LATEST REVISION DATE: 06-11
 APPROVED BY BRIDGE ENGINEER: *Norman E. McQuill*

Iowa Department of Transportation
 Highway Division
 STANDARD DESIGN - 24' ROADWAY, THREE SPAN BRIDGE
PRETENSIONED PRESTRESSED CONCRETE BEAM BRIDGES
 DECEMBER, 2006

PIER BEARING DETAILS H24-41-06

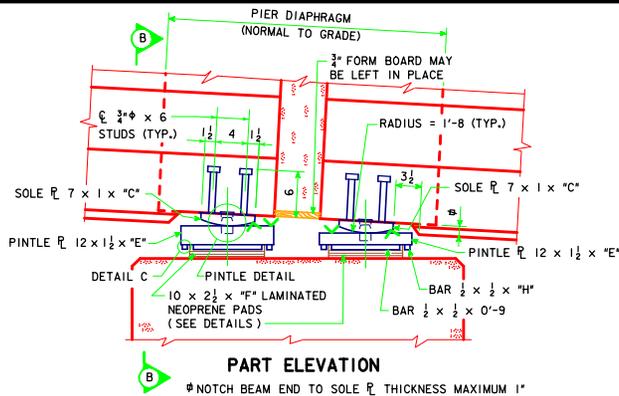
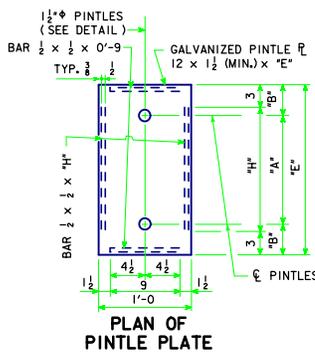
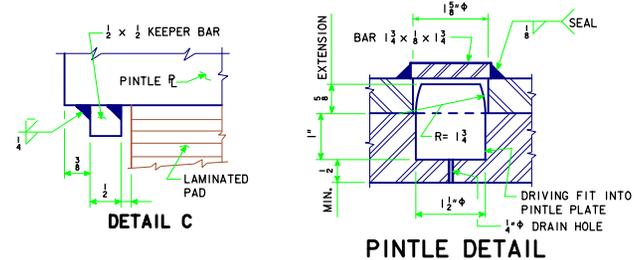
CORRECTION 06-11 - THE REFERENCE TO BAR DIMENSION "A" WAS CHANGED TO "H" IN SECTION B-B FOR A & B BEAMS.
